CITY OF AUSTIN WY 2 APPLICATION TO BOARD OF ADJUSTMENT GENERAL VARIANCE/PARKING VARIANCE

Transmittal		☐ Urgent As Requested		
114	usmittai	☐ For Review and Comment		
		□ FYI		
From:	Bruce S. Aupperle, P.E.	Date: 21Aug14		
То:	City of Austin: Liz Johnston, Rosemary Avila & Andrew Clamann	Delivery: Hand		
Re:	6901 #1 Greenshores Drive SP-2014-0201DS Update #2	Pages: 1

RE: SP-2014-0201DS, 6901 Greenshores Drive, Replacement of Boat Dock

CITY OF AUSTIN - PLANNING AND DEVELOPMENT REVIEW DEPARTMENT SITE PLAN APPLICATION - MASTER COMMENT REPORT

DOWNSTREAM SIDE ELEVATION 1"=5"

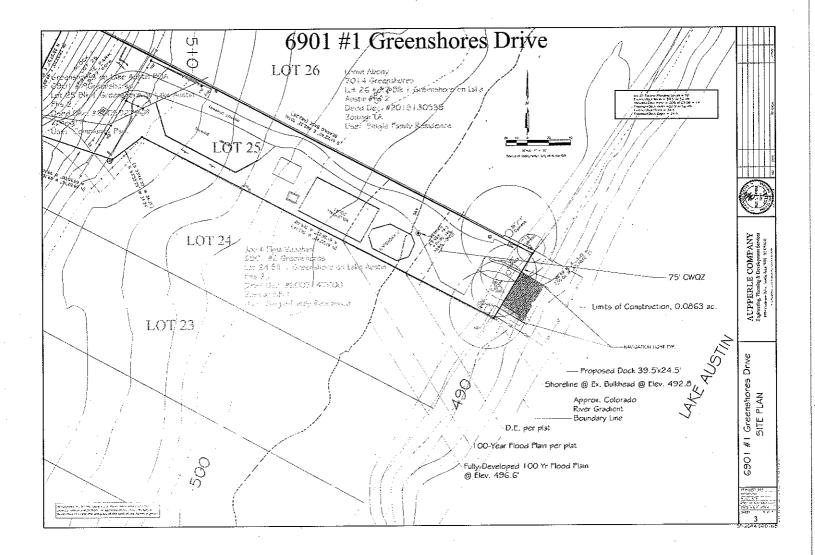
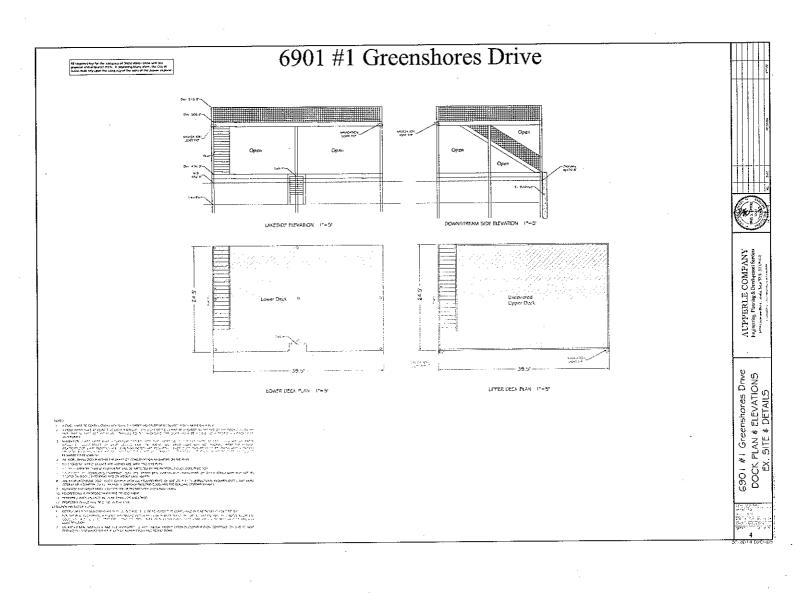
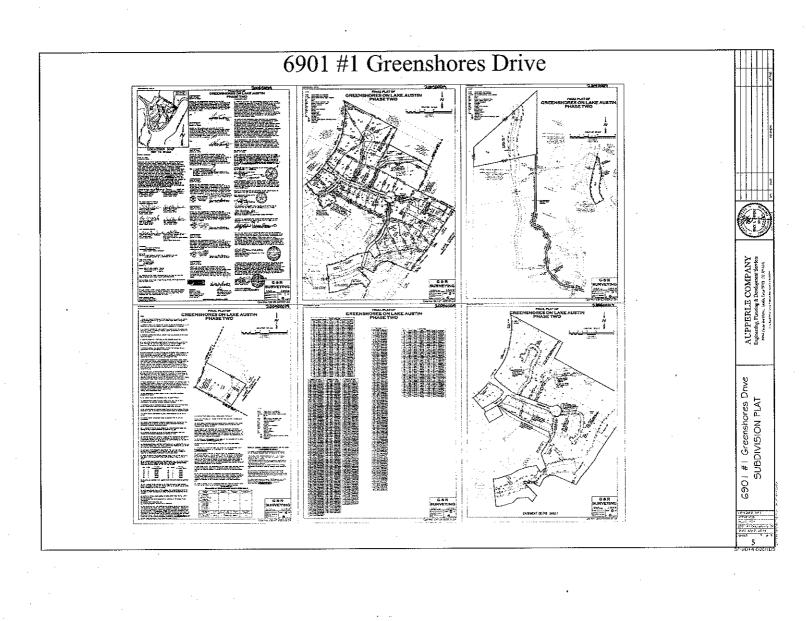
SP2. It appears the proposed swimming dock width exceeds twenty percent (20%) of the length of the shoreline, this must be approved by Planning Commission [LDC 25-2-1176(D)(2)]. Please clarify why the proposed dock is this wide.

- SP3. SP11. Comments cleared.
- SP12. Please add scale to page 3. Also add dimensions (height) for proposed dock, on page 3. U1: Please use Engineering Scale between 1" = 10' and 1" = 40' and divisible by ten. Please add the height for the proposed dock the elevation profiles.

- WB1. Update0. It is my understanding that the applicant proposes to construct a dock that exceeds the limit of 20% of the shoreline. A benefit of the 20% rule is that it provides a reasonable use of the aquatic resource without imposing excessive pressure and degradation of the aquatic resource. Shallow water areas are important to the function and quality of the aquatic resource. Excessive construction of structures which block both sunlight and allochthonous inputs limit the ability for plants, fish and wildlife to function properly. A variance may be required for the proposal. This reviewer does not support the proposed increased impacts to the shore, near shore and shallow water area.

- WB1. Update1. COMMENT NOT ADDRESSED. REPEAT COMMENT. Proposed dock increases impact to shoreline and near shore area by effectively doubling the footprint. The limitation on structure size and extent is designed to support reasonable use of the lake while supporting beneficial chemical and biological function of the shoreline. As stated in UO, A variance may be required for the proposal. This reviewer does not support the proposed increased impacts to the shore, near shore and shallow water area. Please revise accordingly.

- WB1. Update2. COMMENT NOT ADDRESSED. REPEAT COMMENT. Applicant asserts that the proposed dock will not no "wider or deeper" than the existing dock, however, it is clear that the dock will double the footprint and impact a much larger portion of the lake and shoreline. This reviewer does not support the proposed increased impacts to the shore, near shore and shallow water area. Please revise accordingly.

SP2 The new dock will be no wider or deeper than the existing dock, yet the dock will exceed 20% of the shoreline width as noted on plans and in engineer's summary. We understand that BOA approval is required now for this variance..

SP12 Scale is included near north arrow in the upper right quadrant on sheet 3. The height of the dock is included within the detail for Lakeside Elevation in the upper left quadrant of sheet 4.

WB The new dock will be no wider or deeper than the existing dock, nor will the shoreline be modified. Your non-support of the variance to maintain the existing dock footprint is noted.

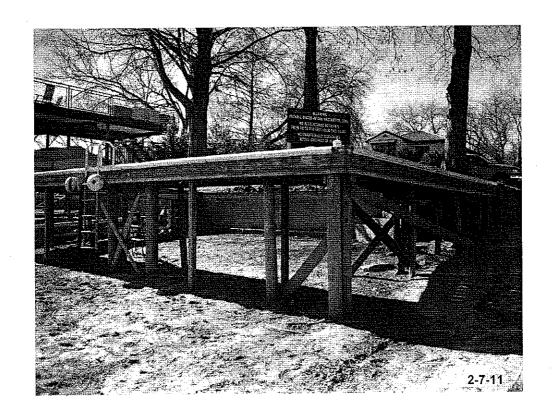
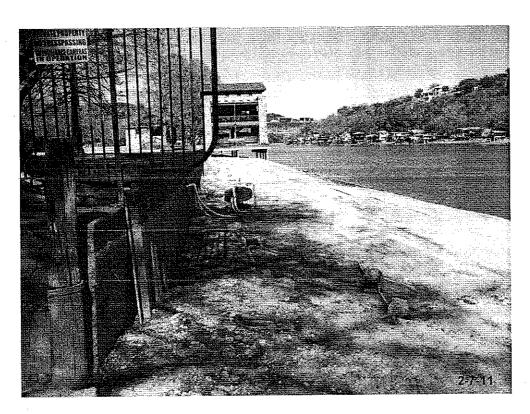
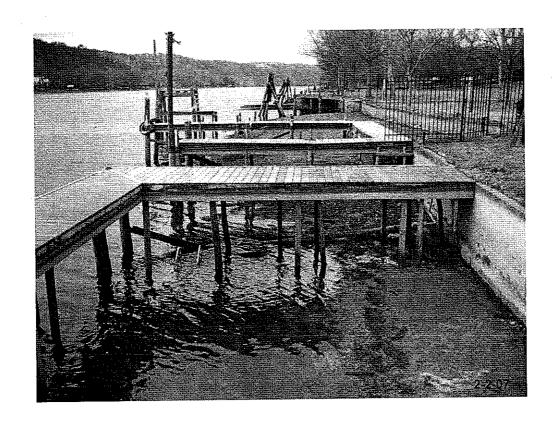
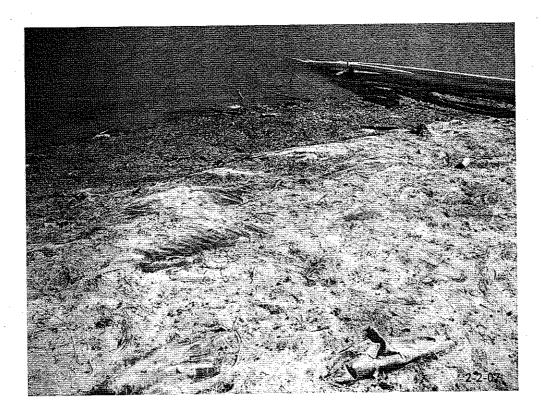
- 1. Excessive construction of structures which block both sunlight and allochthonous inputs limit the ability for plants, fish and wildlife to function properly.
- 2. This reviewer does not support the proposed increased impacts to the shore, near shore and shallow water area.
- 3. A liner does not prevent plant growth, it only hinders/slows progress of certain plants, and therefore is not a reason to support t the proposed permanent structure. Sago pondweed and several other beneficial and innocuous plants and animals are able to exist over liners as sediment builds up and liners break down.
- 4. The proposed doubling of the proposed structure footprint shall further degrade available habitat and shoreline.

Please review the enclosed photographs that I took in 2007 and 2011. They illustrate that:

- 1. There is a liner under and around the existing dock.
- 2. There is not any plant growth in or around the existing dock over the course of four years. Note that the debris in the photos is cypress needles and other material that is not rooted in the soil.
- 3. There are no plants in the exposed shore areas areas with and without docks. Look at the exposed shore areas of the lake that have no docks, and you will notice that there is no plant debris.

The photographic evidence contradicts Wetlands Biologist Andrew Clamann's assertion that plants can grow over liners. The photos reveal that docks, at least the Association's dock, does not limit the ability of plants, fish and wildlife to function properly. That being the case, removing the existing dock and building a new dock with the same footprint will have no impact on plants and fish.
